United States Patent and Trademark Office

APPLICATION NO.	FILING DATE	FIRST NAMED INVENTOR	ATTORNEY DOCKET NO.	CONFIRMATION NO.		
10/671,820 09/26/2003		Michael C. Jones	DEP5086	6924		
27777 75	590 02/22/2006		EXAMINER			
PHILIP S. JO	HNSON	SWIGER III	SWIGER III, JAMES L			
JOHNSON & J	OHNSON N & JOHNSON PLAZA	ART UNIT	PAPER NUMBER			
	WICK, NJ 08933-7003		3733			
			DATE MAILED: 02/22/200	DATE MAILED: 02/22/2006

· · · · ·			Application	No.	Applicant(s)				
Office Action Summary		10/671,820		JONES, MICHAEL C.					
		Examiner		Art Unit					
			James L. S	wiger	3733				
Period fo	The MAILING DATE of this commun or Reply	ication appo	ears on the	cover sheet with the c	correspondence ad	dress			
WHIC - Exter after - If NC - Failu Any	ORTENED STATUTORY PERIOD F CHEVER IS LONGER, FROM THE M Insions of time may be available under the provisions SIX (6) MONTHS from the mailing date of this comm of period for reply is specified above, the maximum state are to reply within the set or extended period for reply reply received by the Office later than three months are and patent term adjustment. See 37 CFR 1.704(b).	IAILING DA of 37 CFR 1.13 nunication. atutory period wi will, by statute,	TE

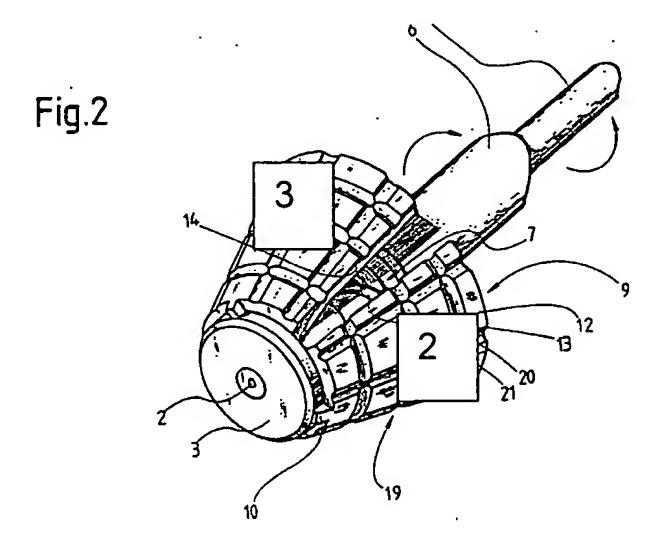
Claims 1-5, 8-13, and 16-19 are rejected under 35 U.S.C. 102(b) as being anticipated by Parhofer et al. (Foreign Patent DE3630069). Parhofer et al. discloses a device having a first component defining a longitudinal axis (see Fig. 3, item 1), and a second component (19) movably associated with the first component (see joint at 10) in a radial direction (Fig. 2). The device further has a body (Fig. 3), and a stem extending from said body (6), and wherein the second component is tapered (Fig. 1). The device also has a restraining portion (8) and a cooperating portion of the second component (10) to provide restrained motion. The device also has a third component moveably

associated with the first component (See Fig. 2 below, and the section denoted as "3" is the third component).

Further, the internal side of component 2 has a surface associated with the first component (on the inside) while the second component has a surface capable of contact with bone material and that is also capable of urging the particles radially (see Col. 2 through Col. 3). The device also provides for a motion of the second component away from the longitudinal axis of the first component as the first component is advanced axially (Col. 5, lines 41-63).
